CITY OF MOUNTAIN VIEW
STEVENS CREEK TRAIL
Reach 4, Segment 2

DRAFT
FINAL ENVIRONMENTAL IMPACT REPORT
SECTIONS I & II

Section II Comments on the Draft EIR And Responses

FIGURE 1

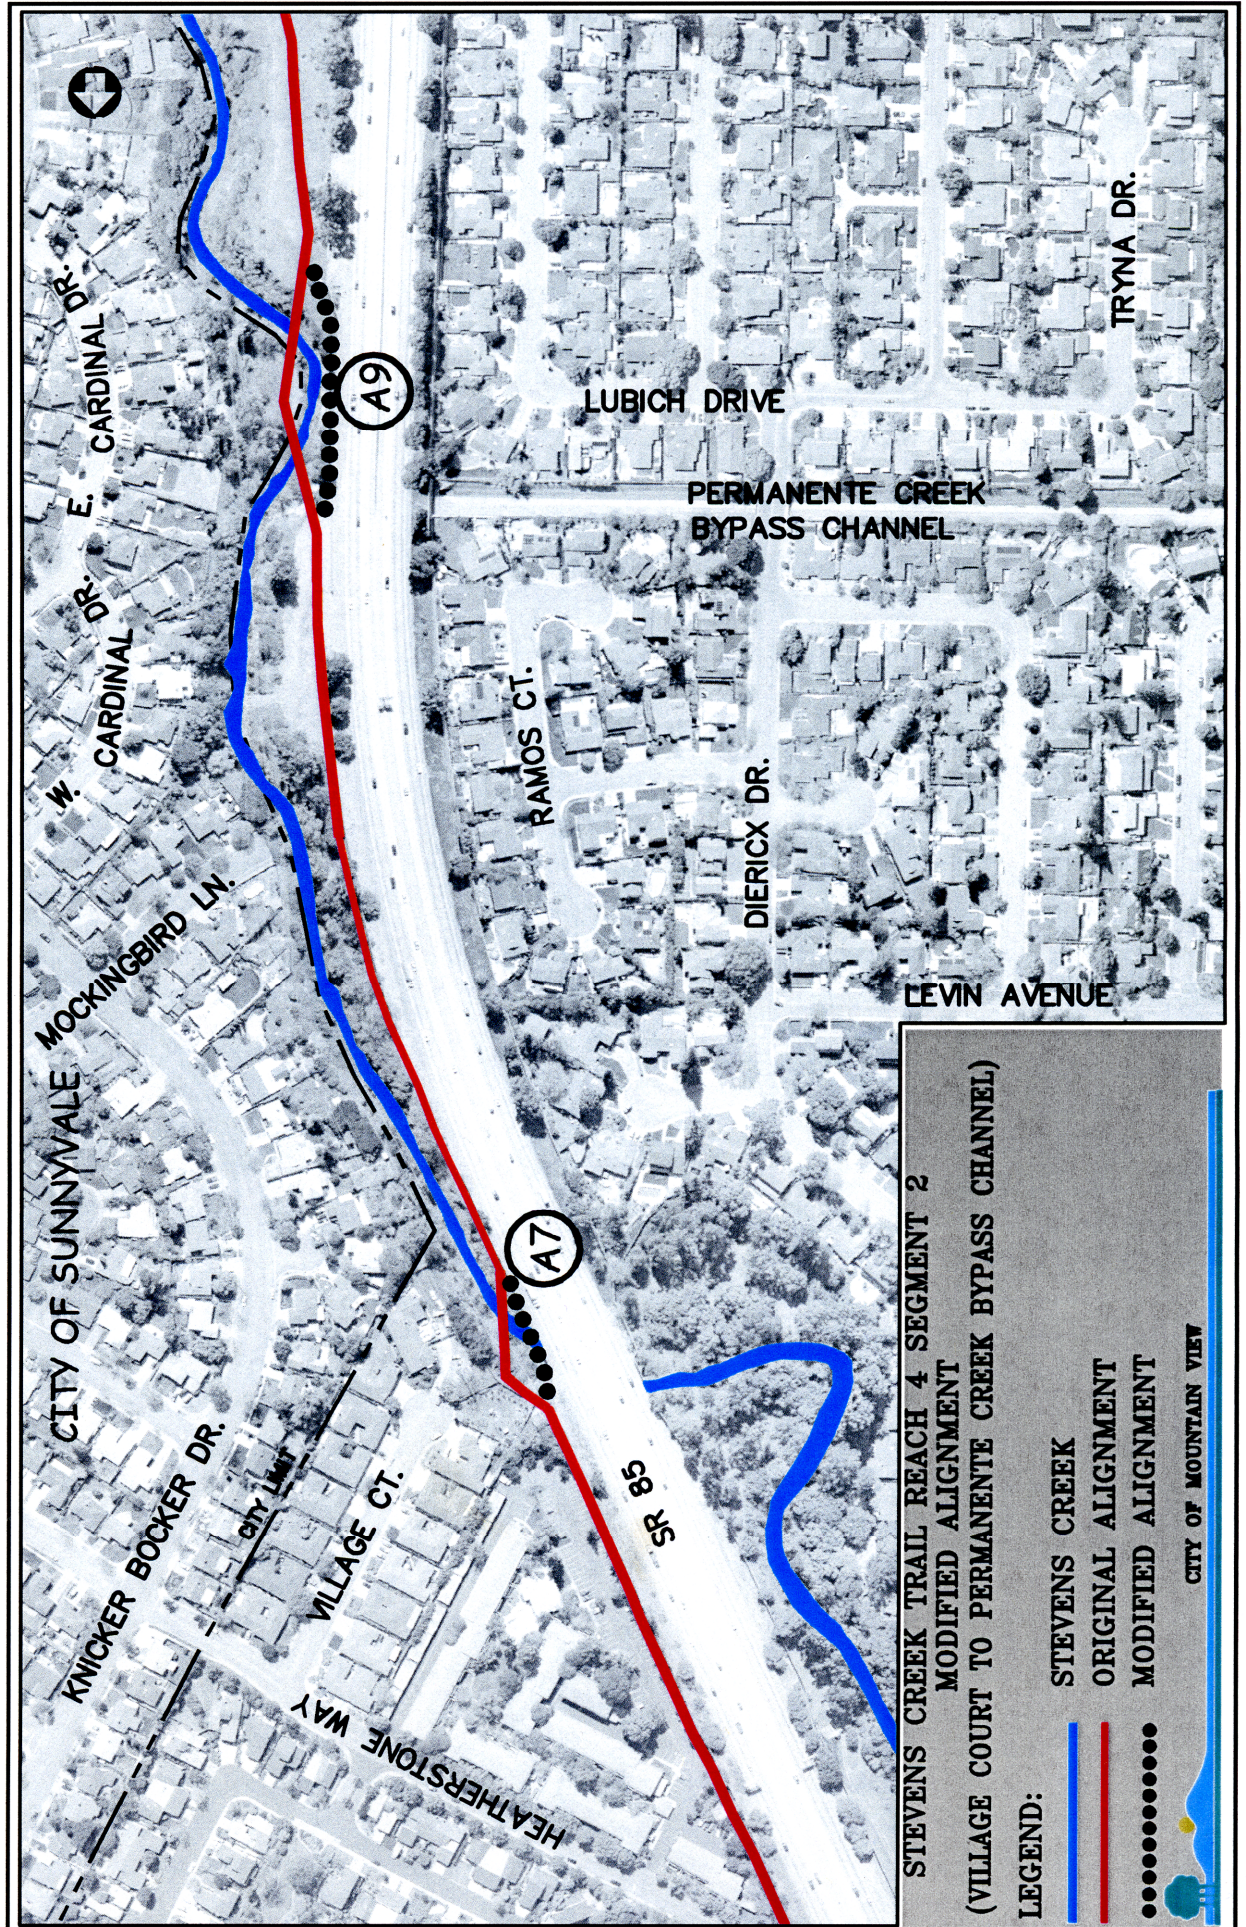
The trail alignments for the area near Village Court (A7) and the Permanente Creek Bypass Channel (A9) have been modified in response to requests by some regulatory agencies that the City look into design alternatives to reduce the environmental impacts of constructing the trail in these locations (please refer to Figure 1). The modified alignment for A7 proposes a single-span crossing of Stevens Creek near Village Court adjacent to the State Route 85 soundwall on the creek side of the wall. Further south at the Permanente Creek Bypass Channel (A9), the modified alignment proposes a single-span bridge adjacent to the State Route 85 soundwall, and avoids crossing Stevens Creek. This modification eliminates the two previously proposed crossings of the creek, a pier within the banks of the creek, and concrete riprap as described in the DEIR. Two possible construction methods for these crossings include an elevated structure supported by piers or the existing soundwall would be replaced with a stronger version that would be designed to carry the elevated trail structure. Please refer to Figure 1 for the revised alignments at crossings A7 and A9.

The modified alignment between Village Court and the Permanente Creek Bypass Channel would also minimize impacts to the creek by facilitating the construction of the trail from the highway side of the soundwall/top of bank of the creek while applying standard construction erosion control measures.
